FCC ID: R6Y-VM4SW

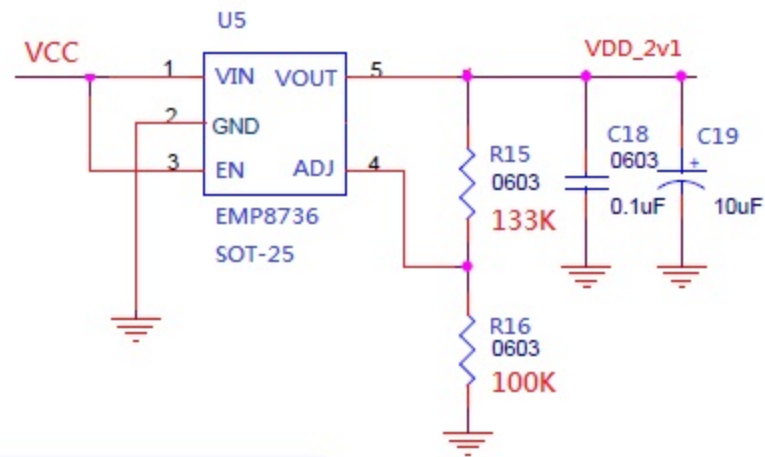
2014-11-13 Change Power IC into EMH7601 (Completed)  
C9/C14 use Tantalum Capacitor

2014-12-15 modify:

1. Change R7/R9 value, Output is 2.65V
2. Change the net name as VCC

2014-12-15 add:

1. EMP8736 (SOT-25)
2. Input net VCC
3. Output net VDD\_2v1
